OBSTRAUPE

Exchange of the Obstraupe handle bar

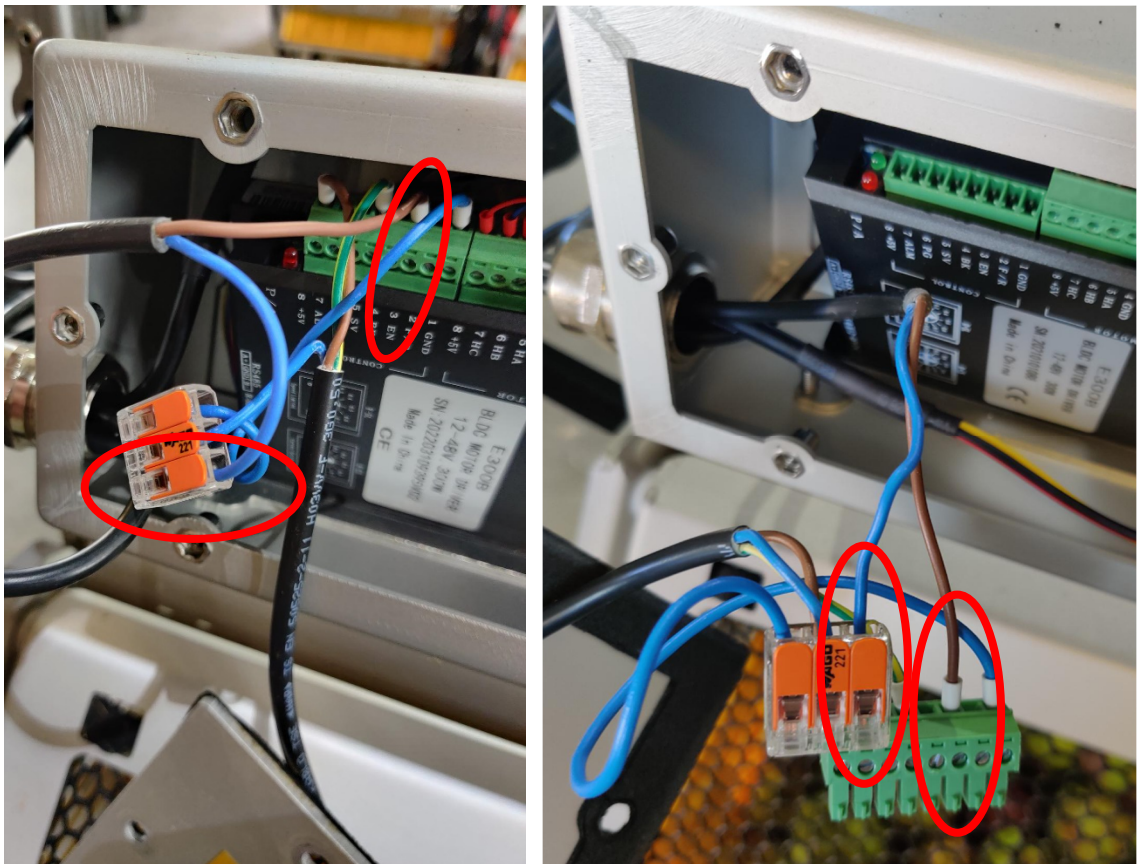
As you may have already noticed, a component from a supplier was delivered in the wrong quality for the 1st batch 2022 (galvanized sheet metal instead of stainless steel). This concerns the adapters with which the handle bar is mounted on the machine. The problem causes these 2 parts to start rusting - but the function is not affected in any way.

This error has been detected by us too late, which is why the handlebar adapter of your Obstraupe is also affected. Please excuse this error. If you want to change the handle, please contact us. We will then send you a handle with adapters made of stainless steel (this is fully assembled, including dead man's switch and locking pins for height adjustment).

1. **Remove the battery from the machine!**
2. Open the cover of the controller box (on which the potentiometer for speed adjustment and the name plate are mounted). To do this, remove the 6 Torx screws.

Attention! The cover remains connected to the machine due to the cable for the potentiometer - do not pull on it!
